# BAYFIELD COUNTY PERMIT

No: 08082202-2022

For: Residential / Residence / 70L x 1W x 6H, Porch: 30L x 14W x1H

RE: Shoreland buffer violation and stormwater management plan for property at 11155 North Long Lake Road, Iron River, WI 54847, described as Govt. Lot 1, Section 35, Township 48 North, Range 08 West. Parcel ID#: 04-048-2-48-08-35-3 05-001-08000. Tax ID#: 30526

# \* SITE SKETCH \*

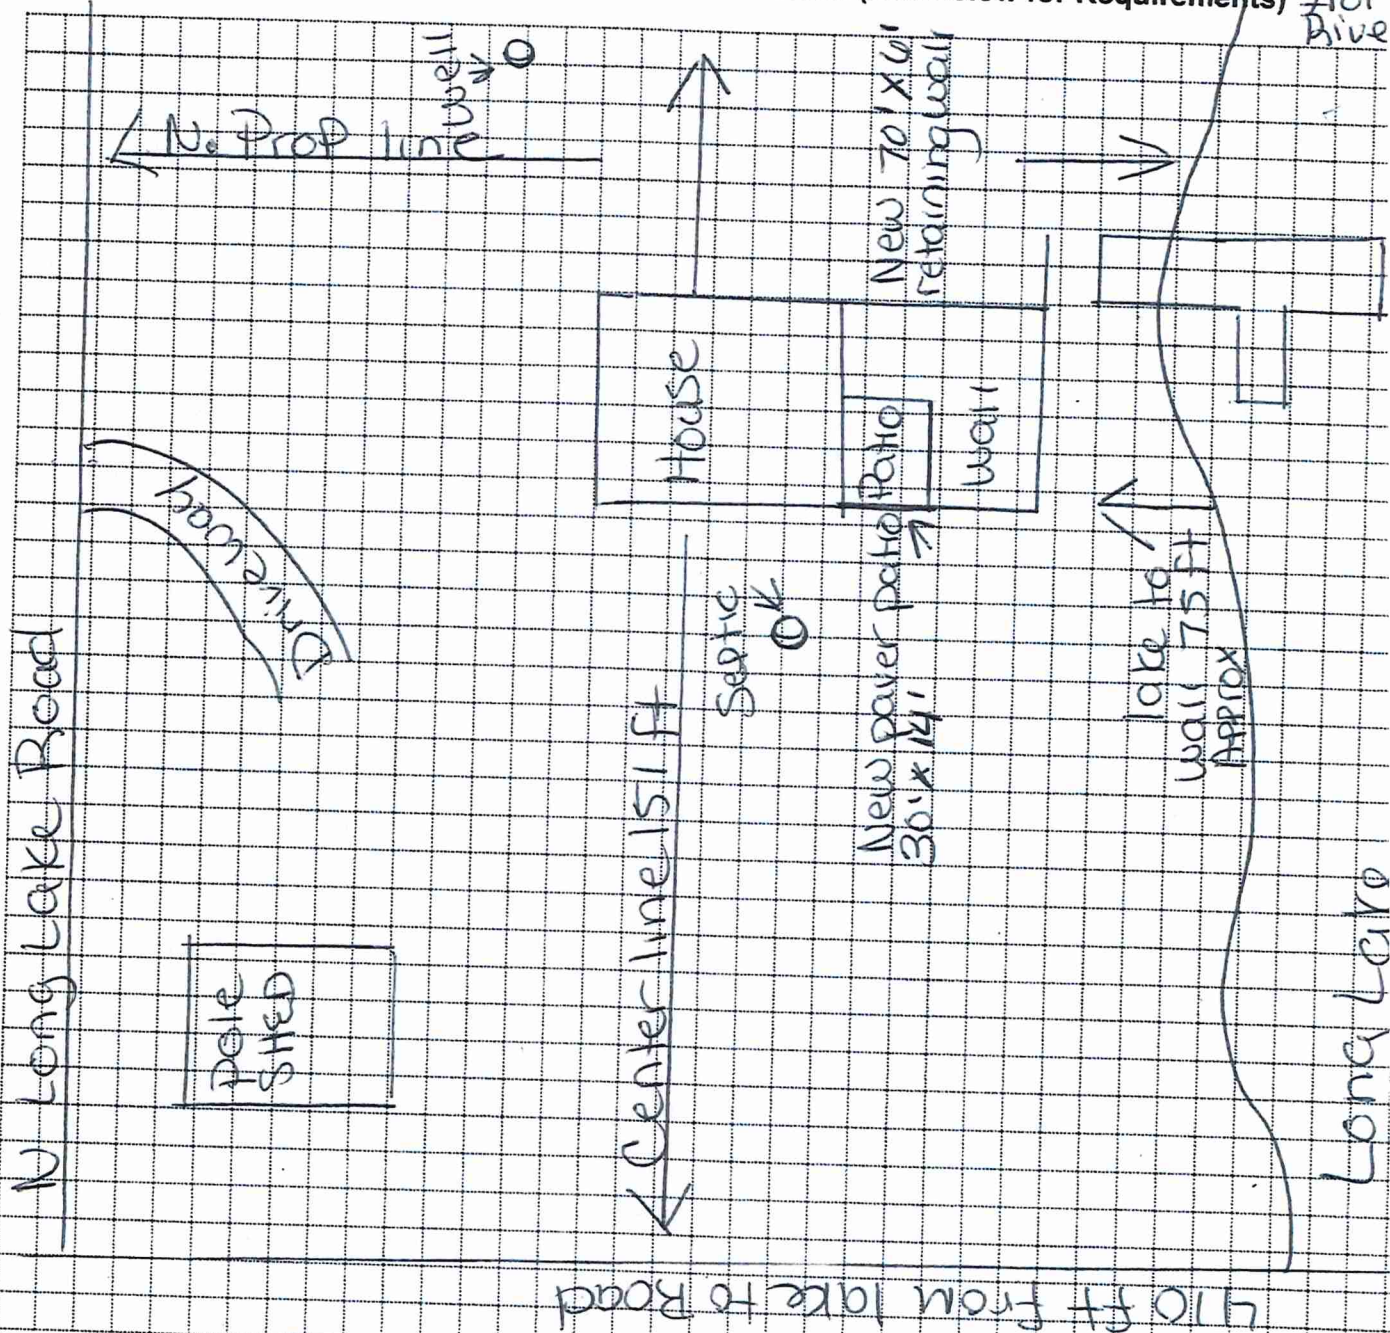
No problem! Could you update the site plan to show that and then we should be good with the site plan.

Okay, it is a little confusing because it shows the paver patio and the retaining wall are the same size but the dimensions are not the same. That may cause confusion.

Is the retaining wall right in front of the patio?

The paver patio is 30'x 14' and the retaining wall is 70'x6' I'm sorry I'm teaching myself how to do these permits. I guess I should of made the patio a little smaller than the retaining wall.  
Thank you for your patience.

Yes that is correct

**\* SITE SKETCH \***

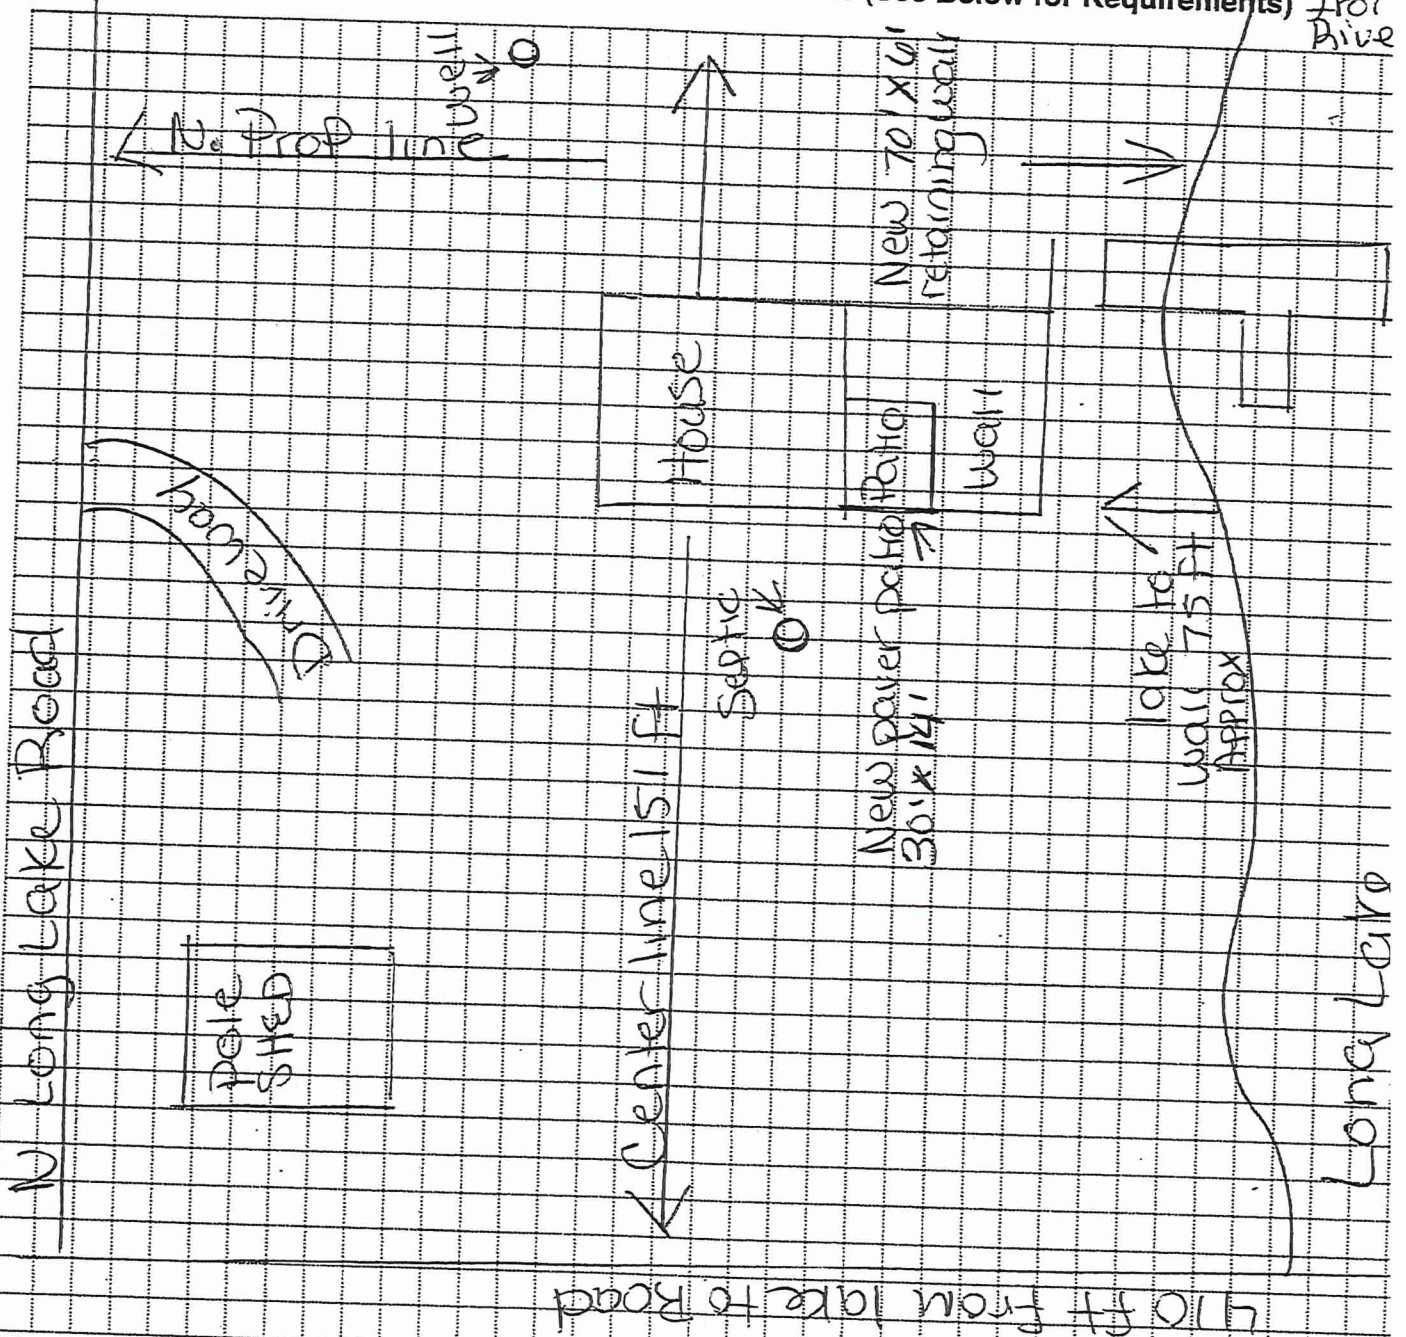
It appears that there has recently been a road constructed all the way to the beach, approximately 45' from the ordinary high water mark. This type of activity would not be allowed within 75' from the shoreline (13-1-22(a)(1)). The area that was turned into an access way will need to be restored up to 75' from the ordinary high water mark.

Additionally, all structures within the shoreland area (1000' from the shoreline) require a permit (13-1-21(b)(7)). We will need an after-the-fact permit for the access way up to 75'. Because there wasn't a permit pull for the access way, the fee will be double.

Also, a Special Class A permit is required for any grading within a shoreland on slopes greater than 20% and/or is required for grading of 1000 square feet or more within a strip parallel to the shoreline inland 300 feet (13-1-24(d), 13-1-24(d)). Because the Class A wasn't filed for the access way, the fee will be double.

Lastly, an impervious surface document will need to be completed on this site (attached). This document should include all impervious surfaces on the lot (driveways, walkways, compacted gravel, decks, buildings etc). The fee for this document is \$100. You are allowed 15% of the total lot area to be impervious. If you are over, mitigation will need to be done.
